PCN/17/010/C+N-US

Product range: M8 Connectors

Title: Injection Molding Change for M8 Sealing Comb

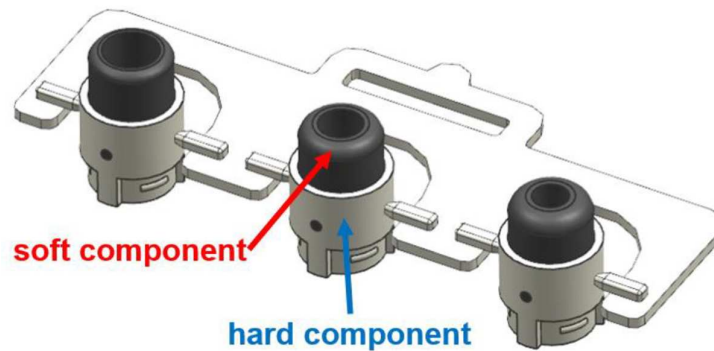
We would like to inform you about a change of the injection molding process for the sealing comb used in our M8 connectors. We changed the order of the injected components during the injection molding process, so that the hard component is injected as the first step and the soft component as the second step.

The above-mentioned change has no impact on the function, product specification or the IP rating of these connectors. All outer dimensions of the sealing remain the same and have no influence on the assembly process.
